Software Update 2009-2

Release Notes

These are the Release Notes for the July 2009 release of GreenStar™ 2 Display 2600 software version 2.4.1156, GreenStar 2 Display 1800 software version 2.0.705, and the Original GreenStar display software version 1.97B.

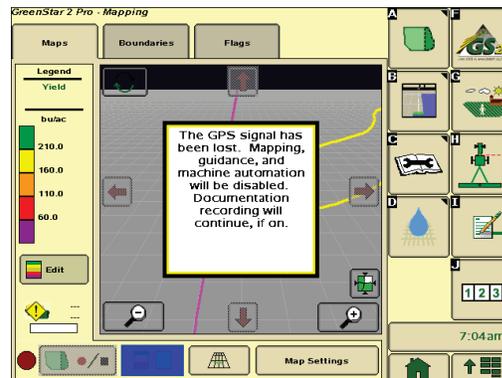
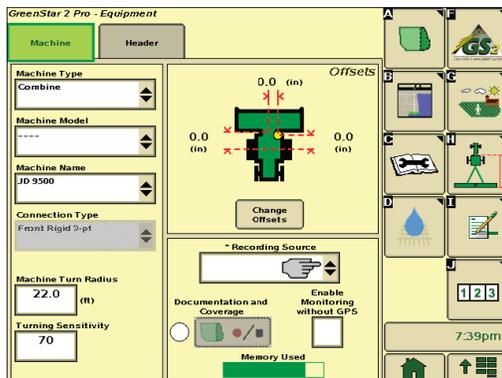
Map name lost for dual variety - If a virtual* planting/seeding operation is created and defined as a split planter the foreground layer, which should correctly display the crop type for the operation, may incorrectly display "Planting/Seeding 1". Performing a warm boot of the GS2 2600 will correctly display the operation name.

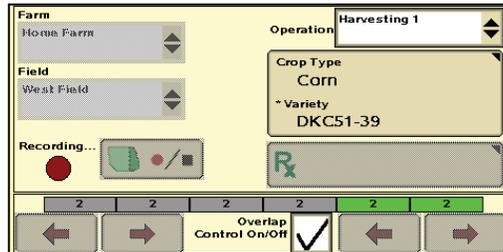
“Overlap Control Disabled” warning turns off Overlap Control - Following an “Overlap Control Disabled” warning message, the Overlap Control check box will become unchecked, turning it off. To enable Overlap Control, the check box can be located and turned back on via *GreenStar 2 Pro* >> *Softkey “H” (Equipment)* >> *Header Tab* >> *Overlap Control On/Off check box*. To more quickly identify if Overlap Control is enabled, it may be configured on one of your run pages.
